Our Ref
PLAN-024366

Date
20/09/2018

Proposal: Outline application with some matters reserved for the demolition of 1 No. dwelling & erection of 10 No.new dwellings, widening of existing access to provide improved visibility splays, maintaining front boundary buffer of approximately 5m in depth, car parking for 30 cars (including garages and visitor parking) & landscaping. Site: Bexstone House, Barnham Road, Eastergate, PO20 3RT. EG/49/18/OUT

Site: Bexstone House, Barnham Road, Eastergate, PO20 3RT.
EG/49/18/OUT

ARUN DISTRICT COUNCIL EG/49/18/OUT

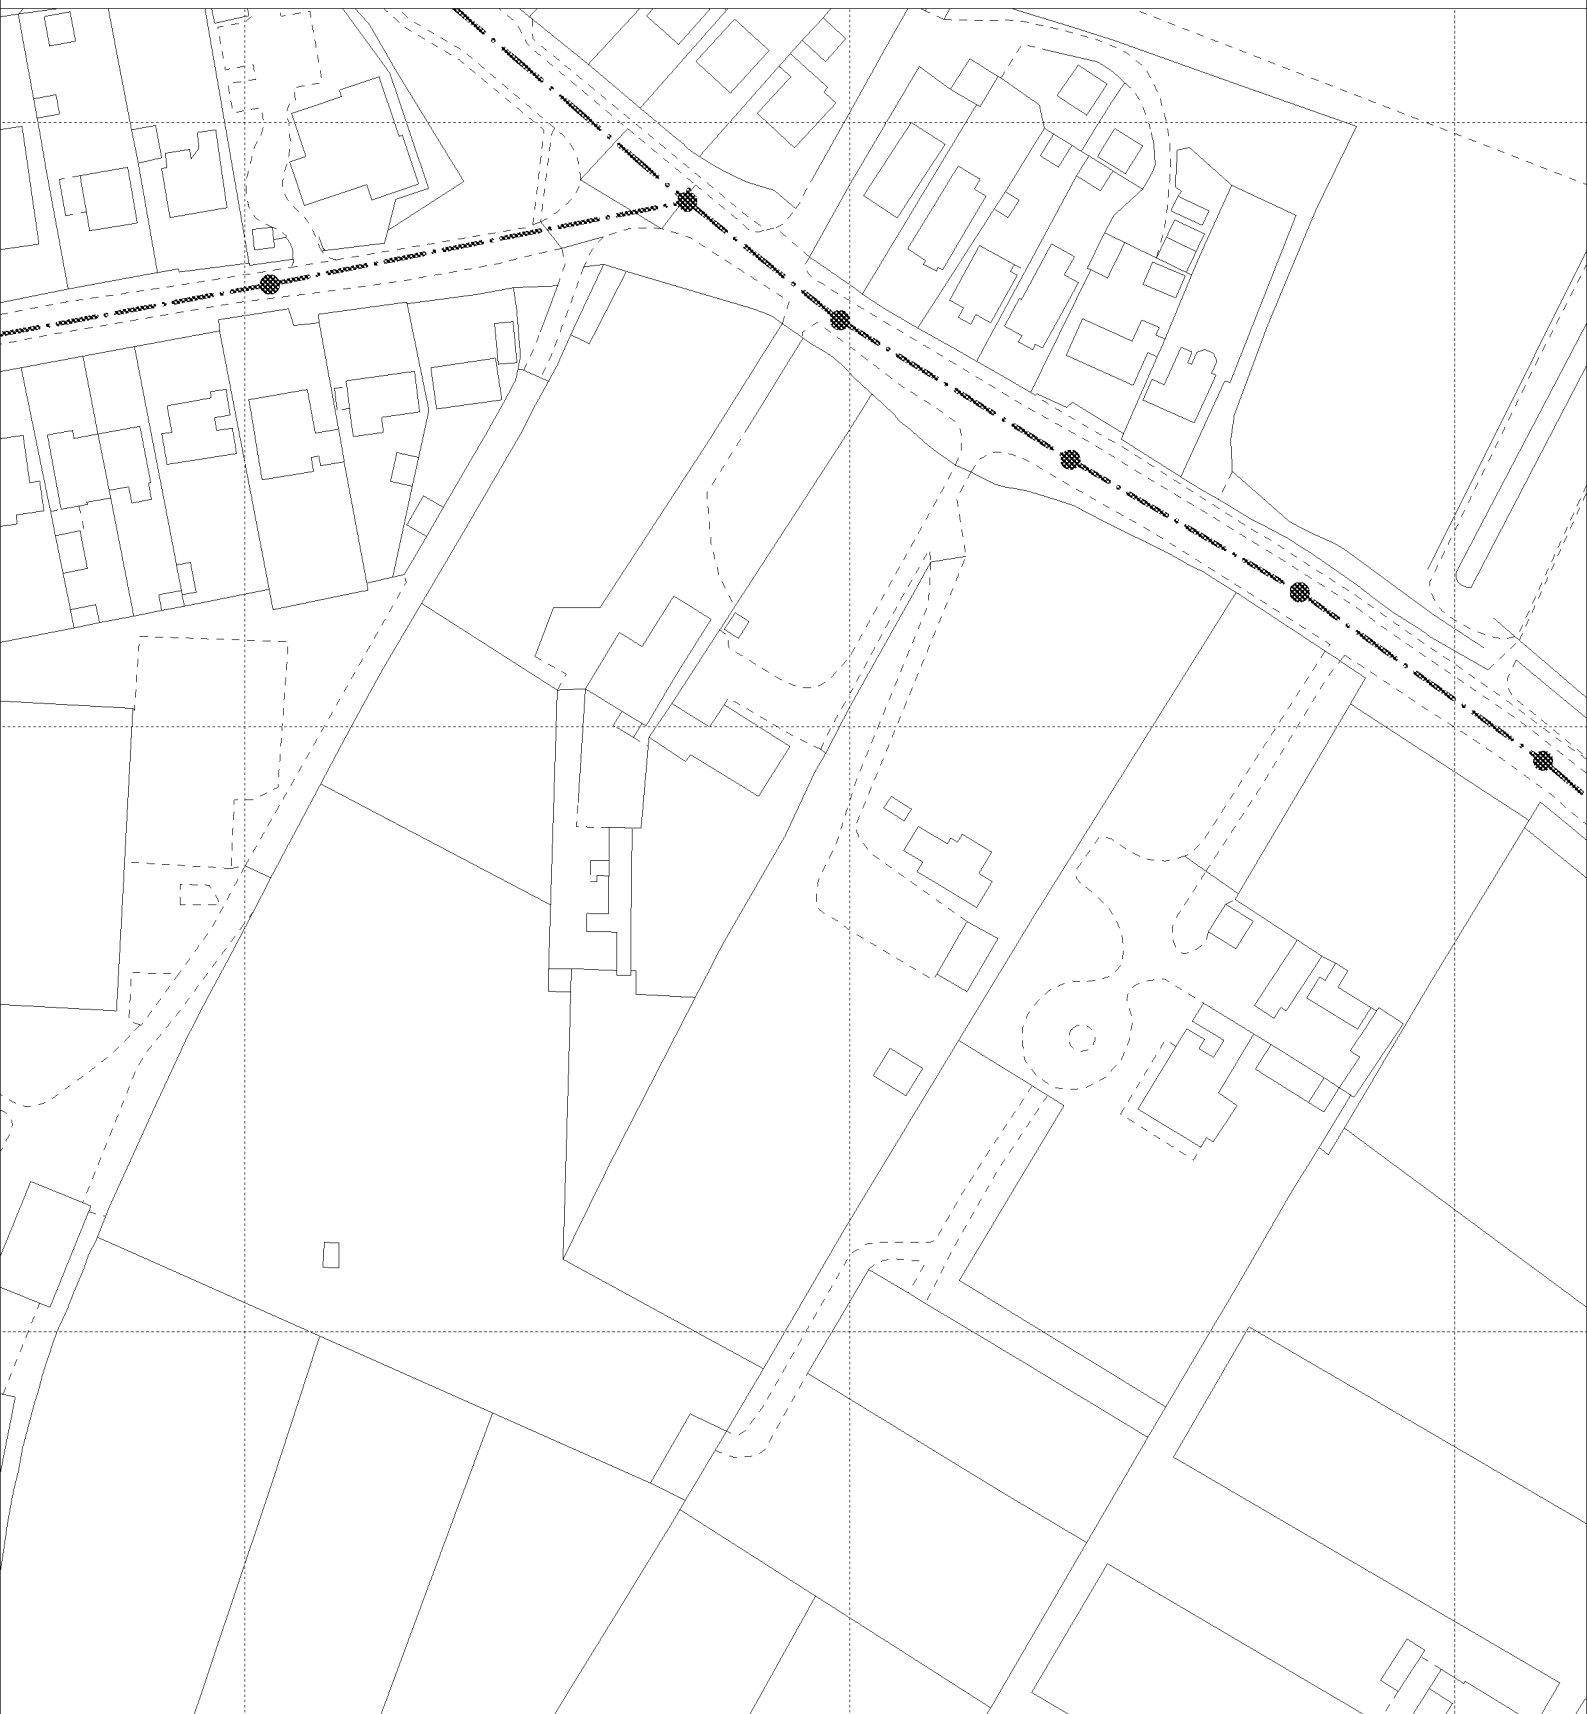
Our initial investigations indicate that there are no public surface water sewers in the area to serve this development. Alternative means of draining surface water from this development are required. This should not involve disposal to a public foul sewer.

Due to changes in legislation that came in to force on 1st October 2011 regarding the future ownership of sewers it is possible that a sewer now deemed to be public could be crossing the above property. Therefore, should any sewer be found during construction works, an investigation of the sewer will be required to ascertain its condition, the number of properties served, and potential means of access before any further works commence on site.

We request that should this application receive planning approval, the following condition is attached to the consent: "Construction of the development shall not commence until details of the proposed means of foul sewerage and surface water disposal have been submitted to, and approved in writing by, the Local Planning Authority in consultation with Southern Water."
